Property Name : 34 - Sunrise Pt/Sunset Cove

Creator : Jose Sanchez

Date : 08/10/2020

Picture: 1

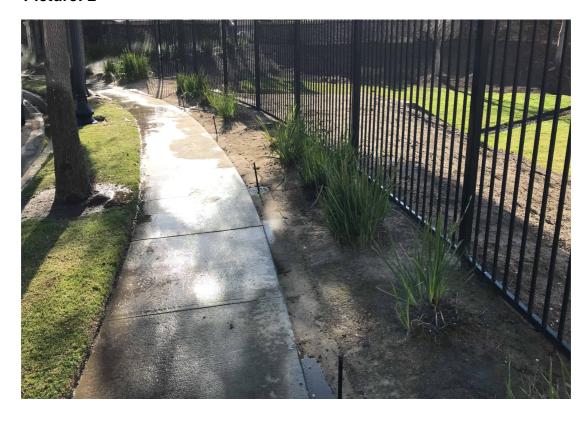
UNSATIS. POOR COVERAGE-UNSATIS. POOR COVERAGE

Notes: Poor watering coverage on Rainbird rotor T 40.
